**RE: TREE PROTECTION PLAN FOR 2040 ARROWSMITH DRIVE, OTTAWA**

This tree protection plan was prepared by IFS Associates Inc. (IFS Inc.) in support of a building permit for 2040 Arrowsmith Drive in Ottawa. The need for this report is related to trees protected under the City of Ottawa's Tree Protection By-law (By-law No. 2020-340). The work proposed includes demolishing existing buildings and construction of a six-storey mixed-use building (see plan on page 7 of this report). A driveway with retaining wall and curb is proposed for the rear of the building and is adjacent to a stand of trees on the neighbouring property at 2000 Jasmine Crescent. This plan details efforts to ensure the successful retention of these trees.

### RESPONSES TO CITY COMMENTS

DRAWING: Tree Protection Plan

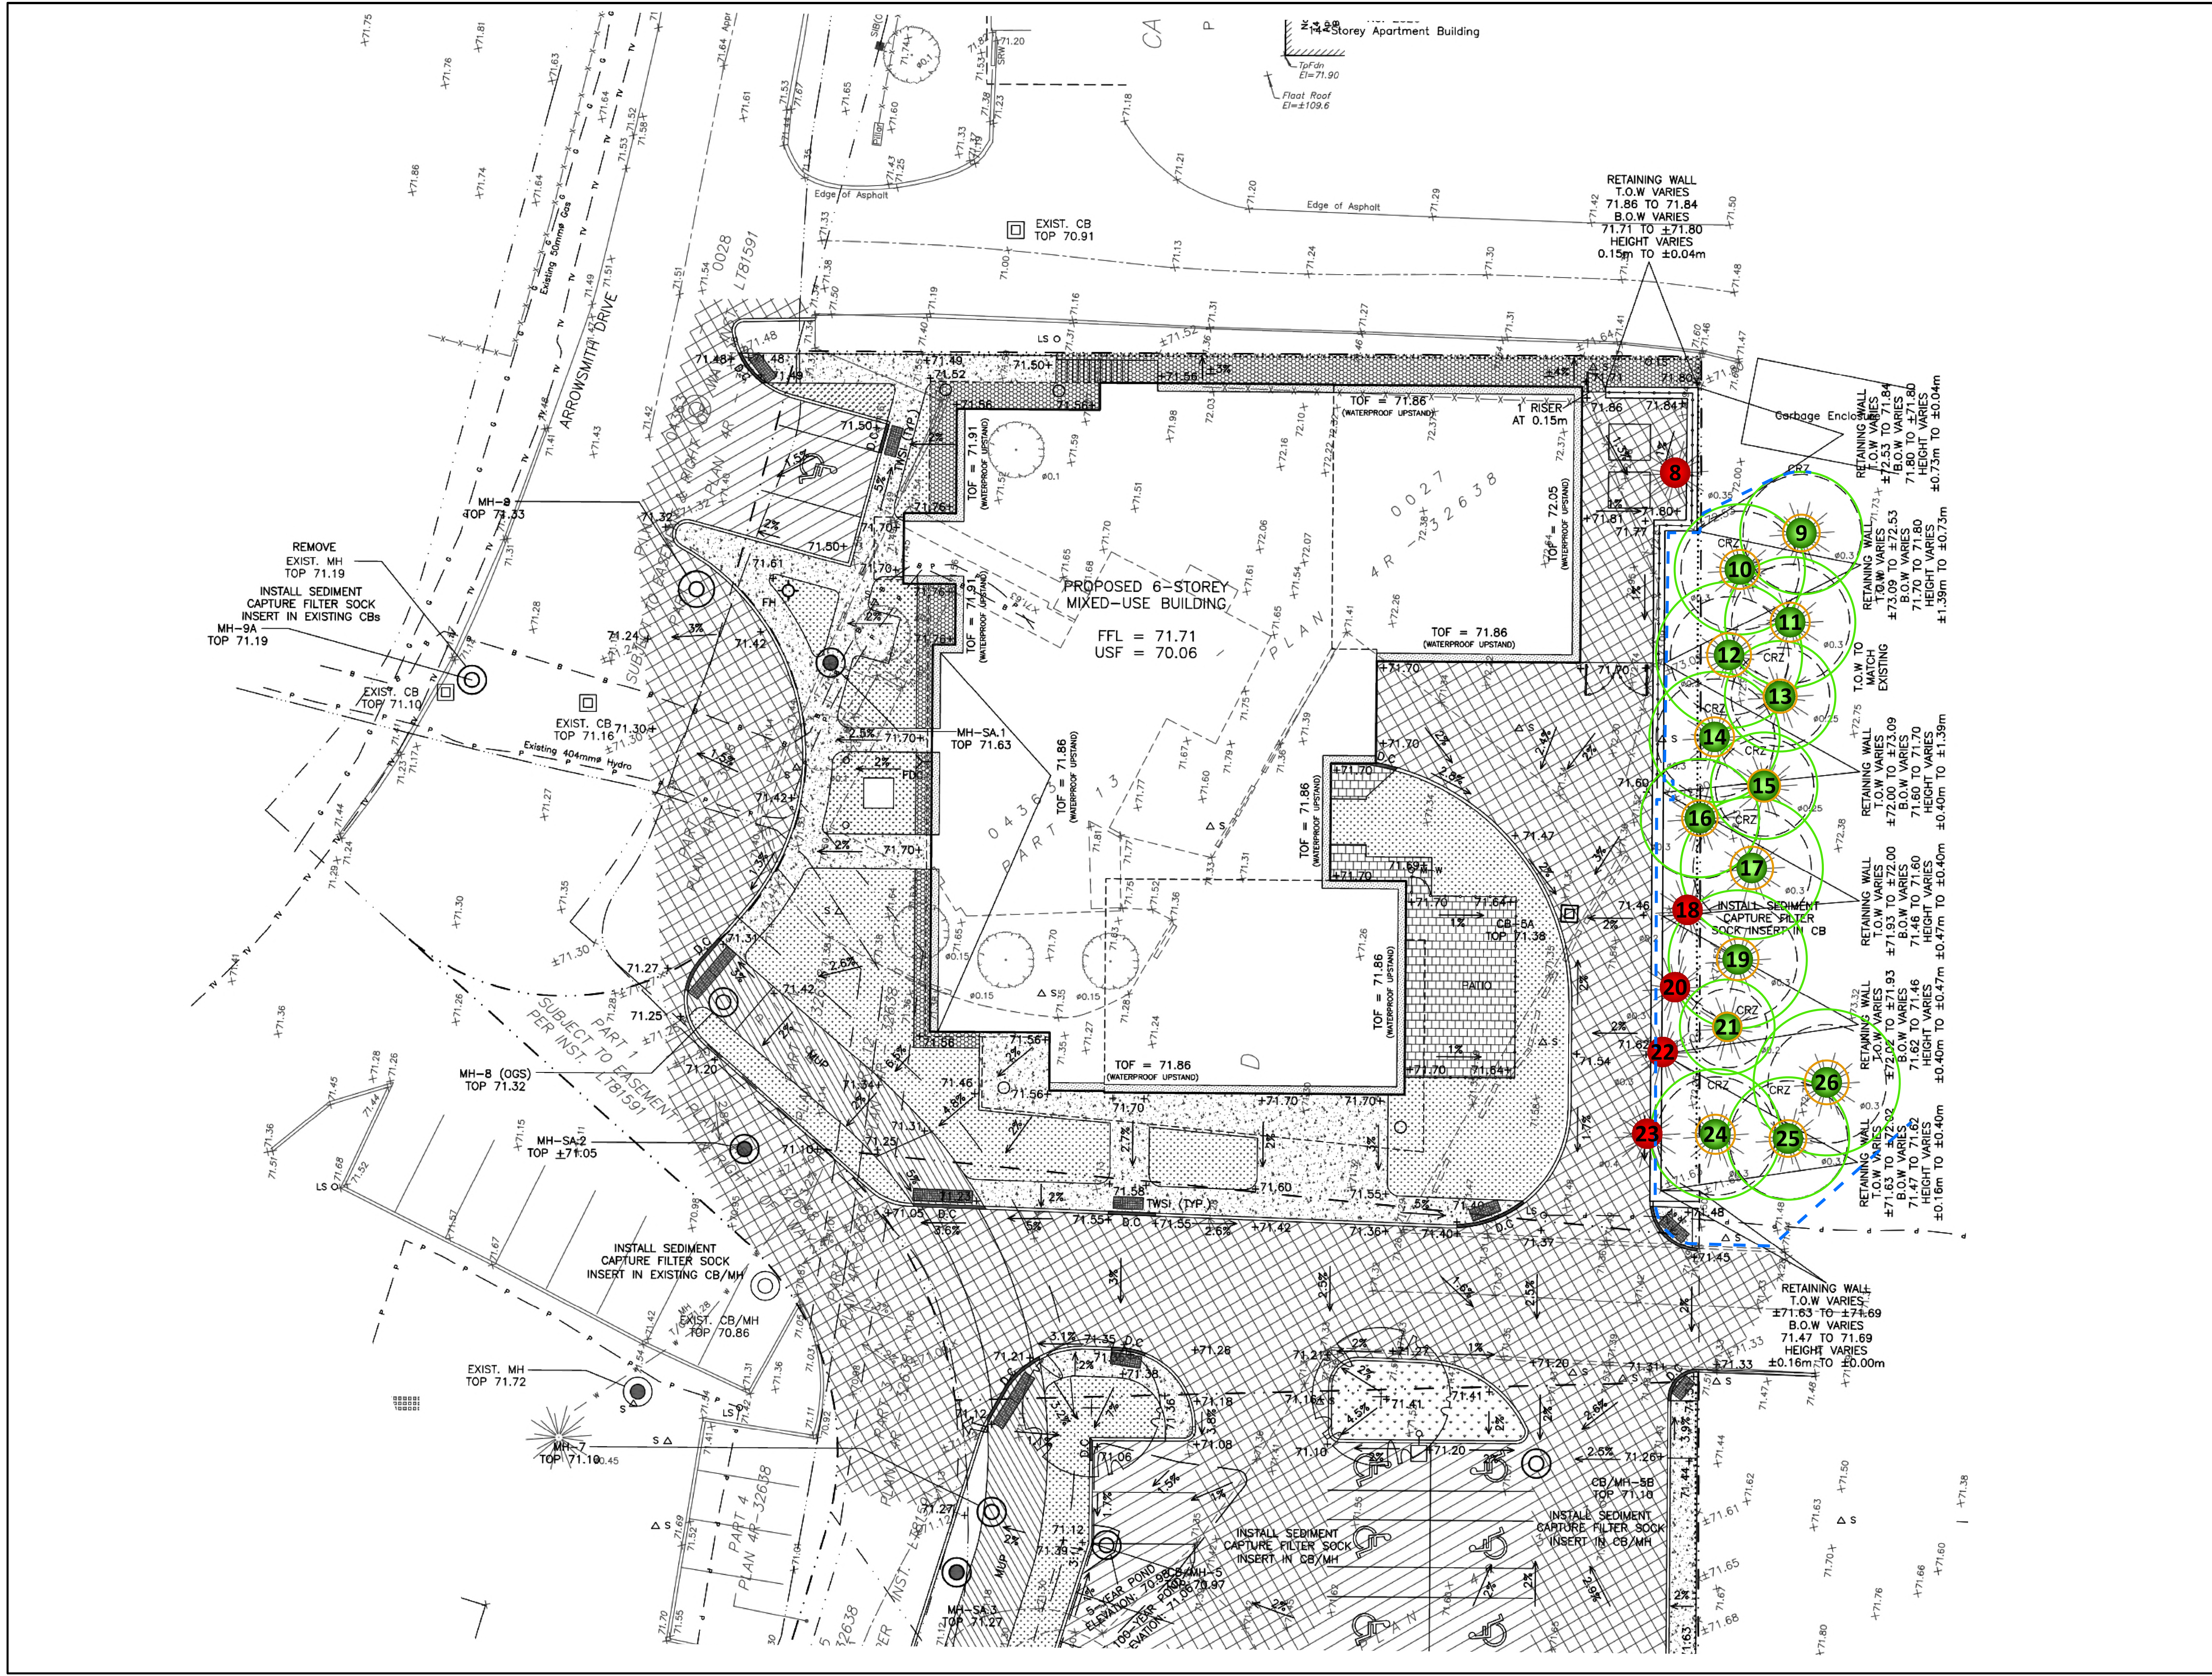
1b) *What extent of impact to the CRZs of these retained trees will occur and will it cause retained tree health to decline? Will there be excavation within the static root zone of the tree (Diameter x 3)?*

1g) *The consulting engineer and RPF must discuss the grade changes proposed along the eastern edge of the site. The trees are growing on a berm. A retaining wall, curb and access road will be installed along the edge of this growing space. Identify the implications of this work in the plan.*

At most, 30% of one tree’s CRZ (tree #16) will be impacted by grading. This equals the maximum recommended in ISA best management practices. As shown in the plan on page 7, no static root zones will be impacted.

The consulting engineer and forester have discussed the implications of the work proposed along the eastern edge of the site. Grading behind the proposed retaining wall remains as existing. Approximately 30% of the CRZ of tree #16 will be impacted while lesser amounts of the CRZs of trees #10, 12, 14 and 24 will be impacted.

Tree Protection

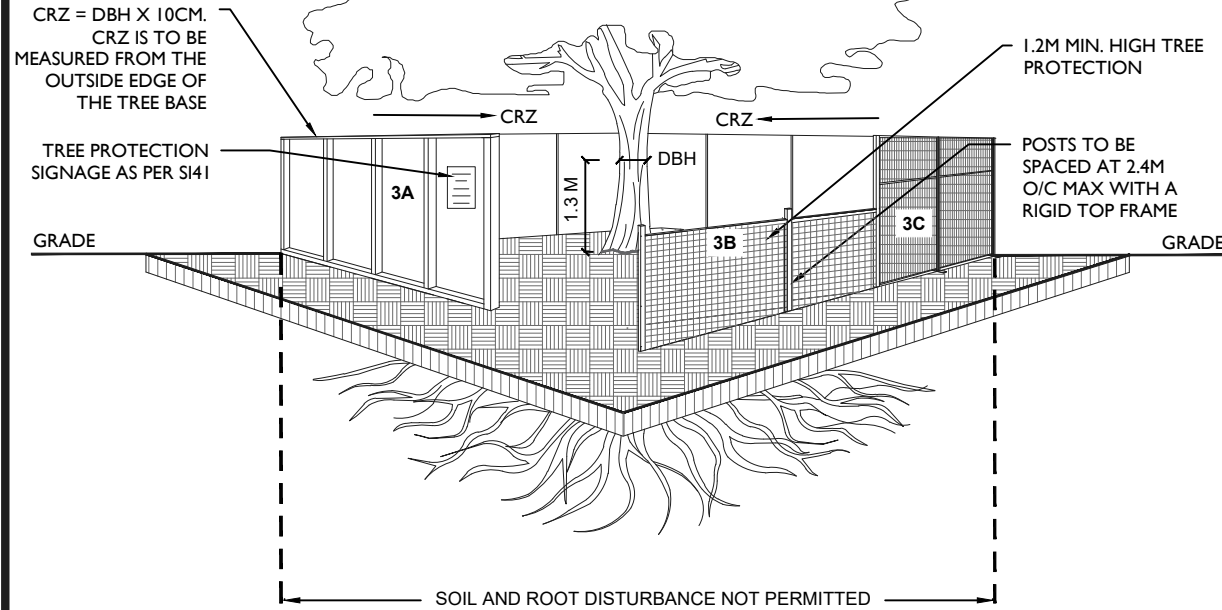
1a) *How will the trees shown as “to remain” be protected through the grading work and retaining wall installation?*

As detailed in tree protection measures, a protective fence will be installed following the City of Ottawa’s tree protection barrier specifications.
